Amended
Architectural Review Board Agenda
4:00 PM Tuesday, July 8, 2025
Sussex Civic Center – Committee Room Second Floor

MEMORANDUM

TO: Architectural Review Board
FROM: Gabriel Gilbertson, Community Development Director
RE: May 7, 2025 Architectural Review Board
DATE: Friday, June 27, 2025

- I. **Roll call.**
- II. **Consideration and possible action on the ARB minutes of April 2, 2025.**
- III. **Discussion and possible action on a Plan of Operation, site plan, landscape plan, architecture plan, and lighting plan for Scooter's Coffee located at the southwest corner of Business Dr and State Highway 164.**

1 WEST ELEVATION
SCALE: 3/8" = 1'-0"

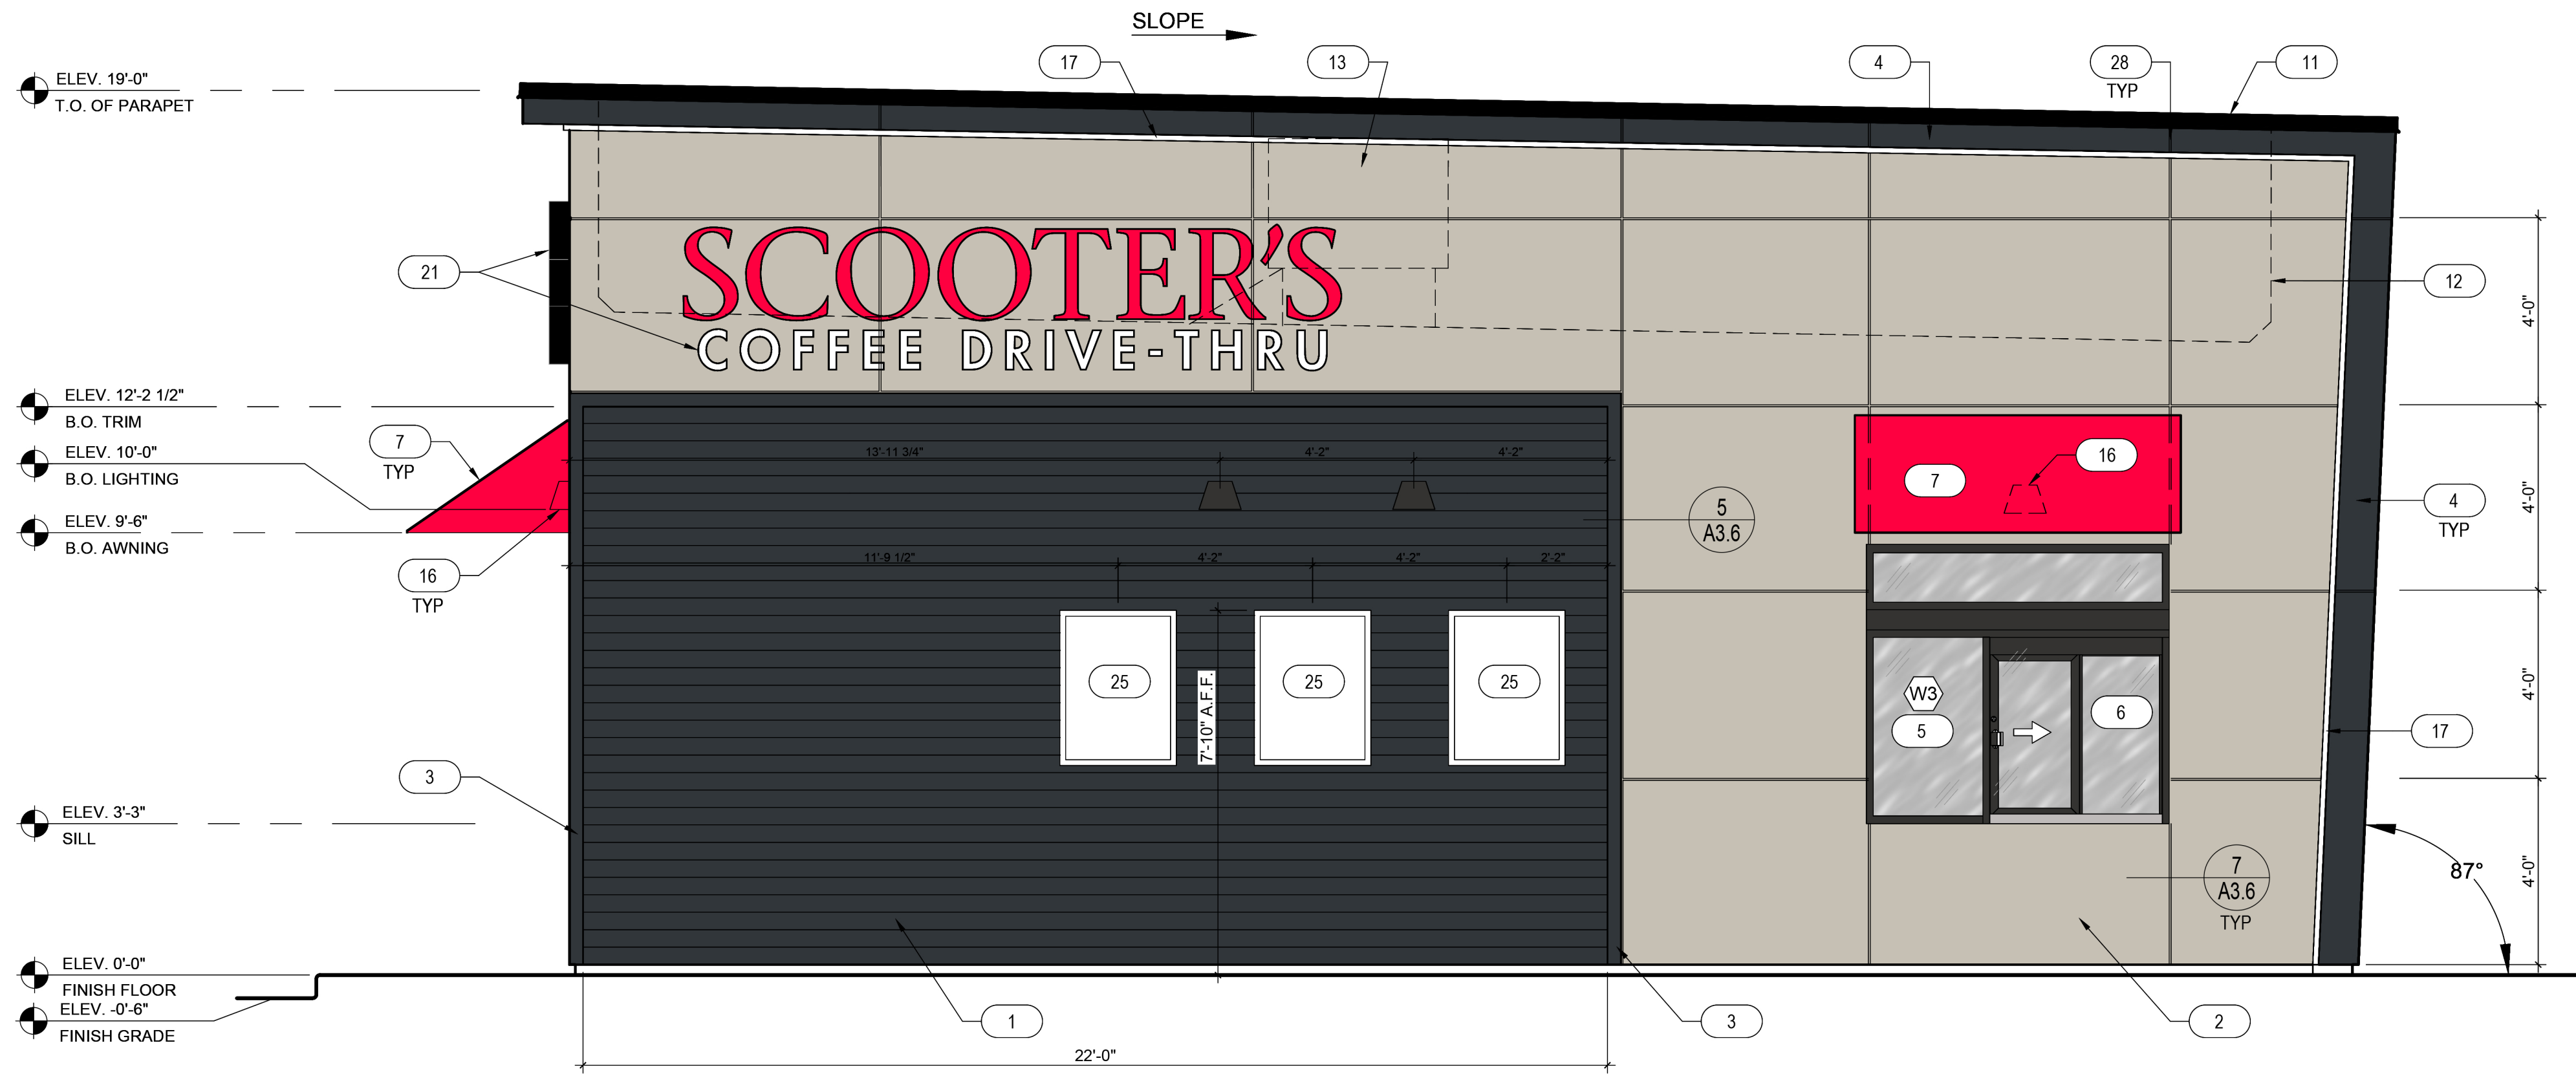
- Building meets height and required setbacks.
- Roof top units are to be screened from view.
- Materials to be used meets the Design Standards.
- Revised elevations that meet 33% window and door openings are required.

1. Submitting a revised landscape plan that meets the minimum requirements of the Sussex Design Guidelines.
2. Submitting a revised lighting plan that includes details for light fixture mounting height and pole bases.
3. Compliance with the comments and conditions of the Community Development Department in the memo dated May 28, 2025.
